Addendum No. 3
City of Coquitlam
Tender No. 81832 - Phase 2
Cedar Drive Upgrades - Sanitary Pump Station to Gilleys Trail
 (Consists of 23 Pages)
 Issue Date: May 6, 2025

Tenderers shall note the following changes:

Large Woody Debris Anchoring Detail in off Channel

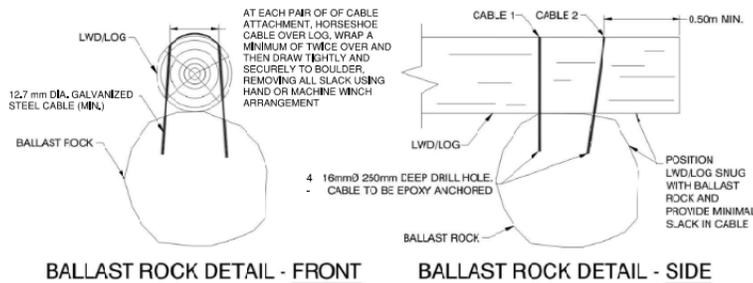
Q1.) Will all the woody debris (logs, snags, etc.) be “anchored” to the boulders? This would typically done with cable and anchors drilled and adhesived into the boulders.

A1.) The 9 LWD structures in the off-channel do not require cabling or adhesives. These locations can be secured using a rock ballasting approach by weighting down the structure with sufficient mass of boulders to prevent the structure from floating away (see Attachment 1 for details).

i. For rock ballasting in the off-channel, the Contractor shall assume 8 boulders ranging between 450mm to 1000 mm in diameter will be required for each LWD structure.

ii. The Contractor may at their discretion cable and rock anchor the LWD structures in the off channel.

The 10 LWD structures in Partington Creek will require cable and rock anchor per attached detail (Attachment 1).

ROCK BALLAST QUANTITIES DEPENDENT ON LENGTH AND DIAMETER OF LWD PROCURED BY CONTRACTOR, CONTRACTOR TO REPORT LWD LENGTH AND DIAMETER TO PROJECT ENVIRONMENTAL MONITOR WHO WILL CONFIRM ROCK MASS AND APPROPRIATE BOULDER SIZE CLASS.

CONTRACTOR TO PRICE ROCK ANCHOR BALLAST BASED ON BOULDER SIZE RANGE OF 0.6 m to 1.1 m DIAMETER, ROCK MASS, DIAMETER AND BOULDER COUNT TO BE CONFIRMED AT CONSTRUCTION ONCE LWD LENGTH AND DIAMETER IS PROVIDED TO THE ENVIRONMENTAL MONITOR, CONTRACTOR TO ASSUME A MINIMUM OF 3 ROCKS PER LOG FOR TENDER.

STA 0+580 TO 0+720
CEDAR DRIVE UPGRADES - PHASE 2

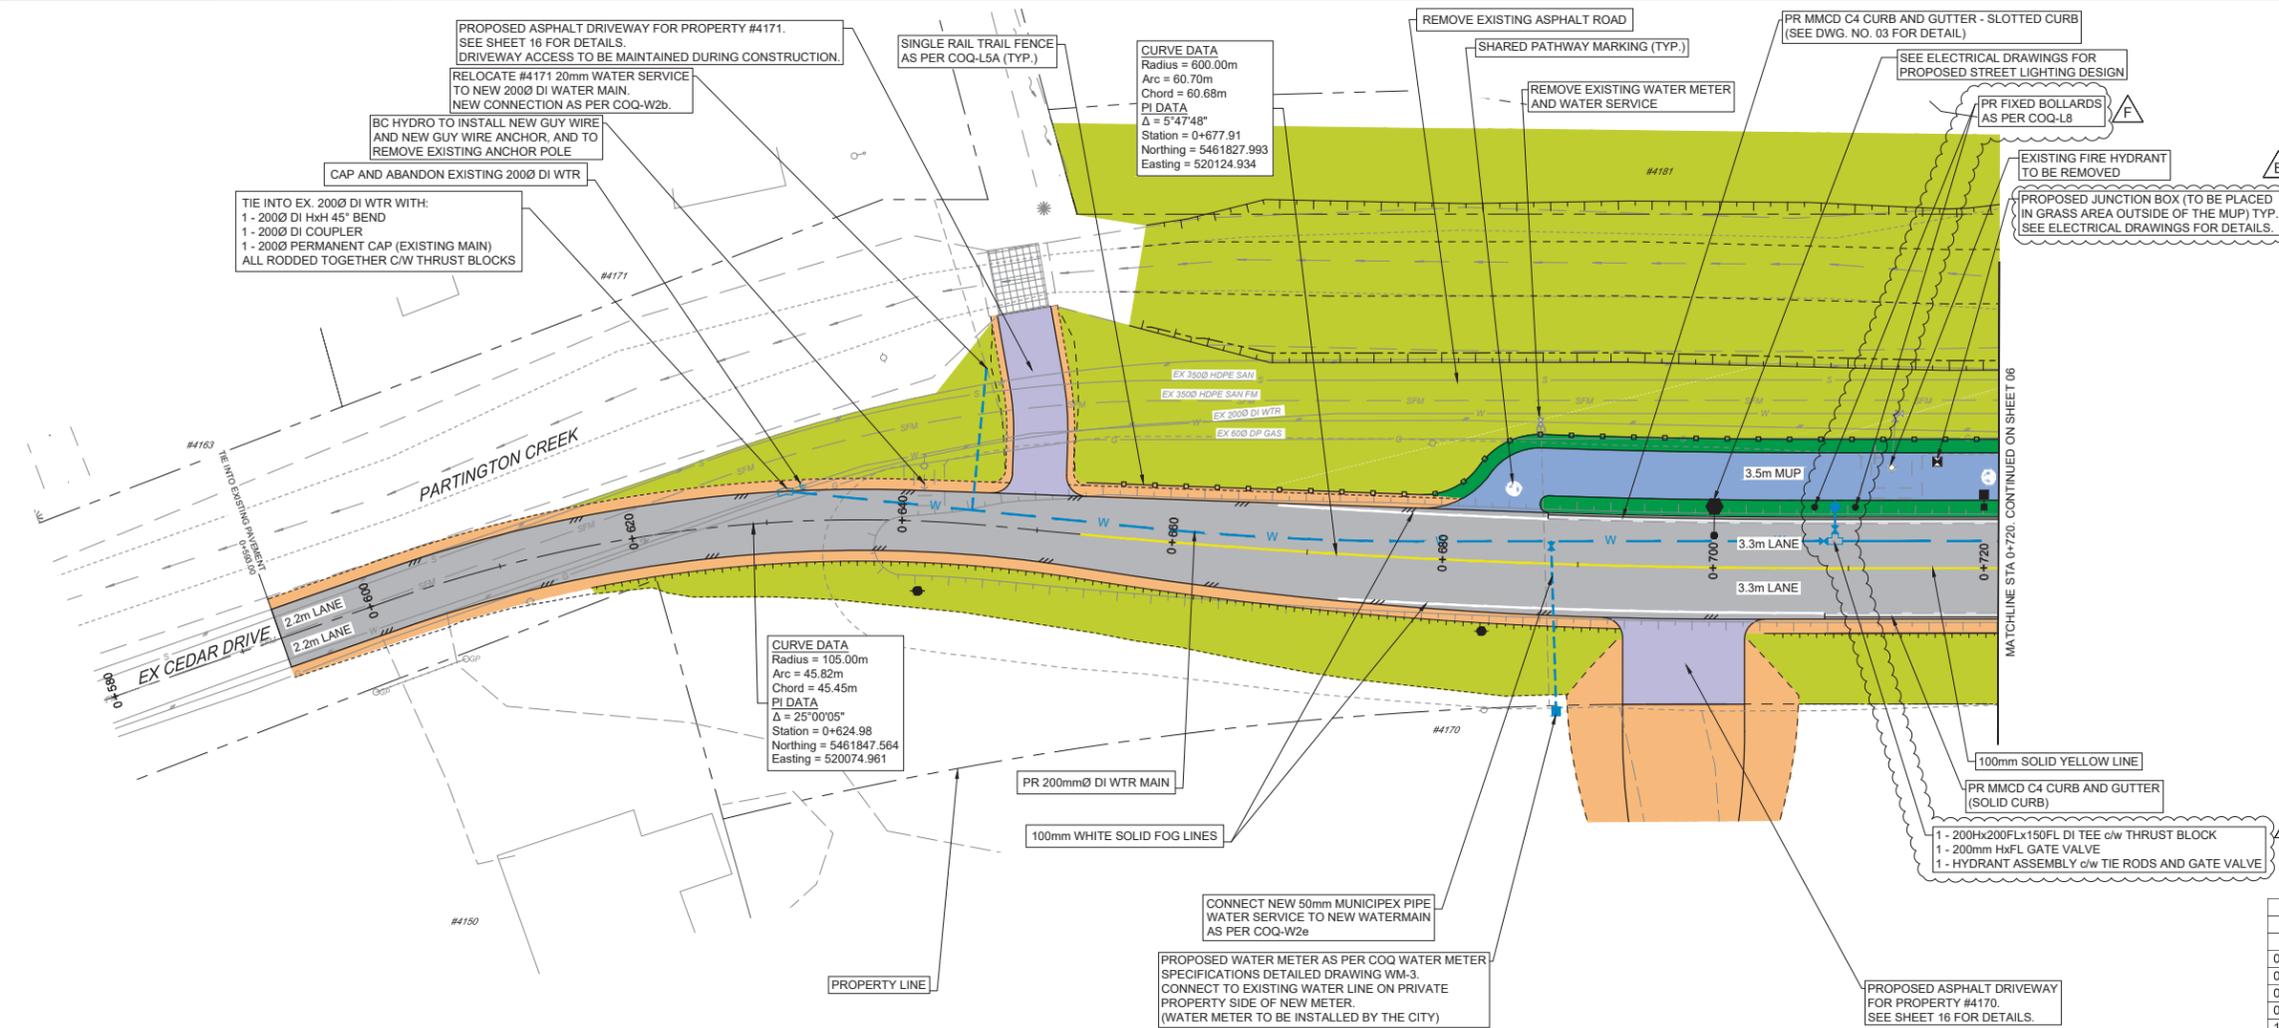
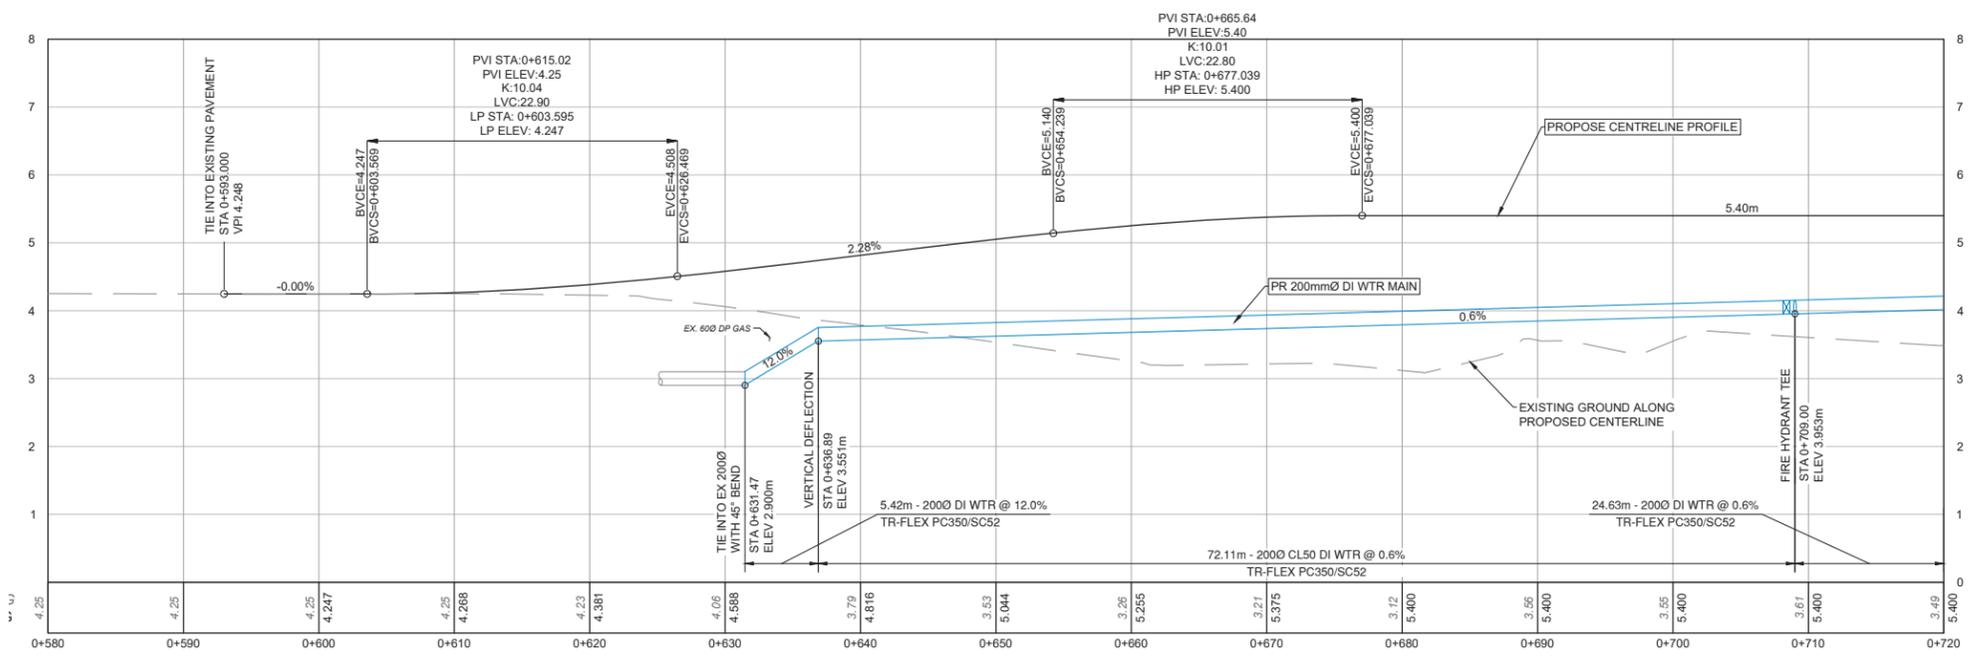
Q3.) Can the fire hydrants be moved closer to water main on the other side of the road?

A3.) Hydrants moved to nearside boulevard (new lead length 2-3m). Extra 150 Gate valve not required. Refer to Revised Drawings.
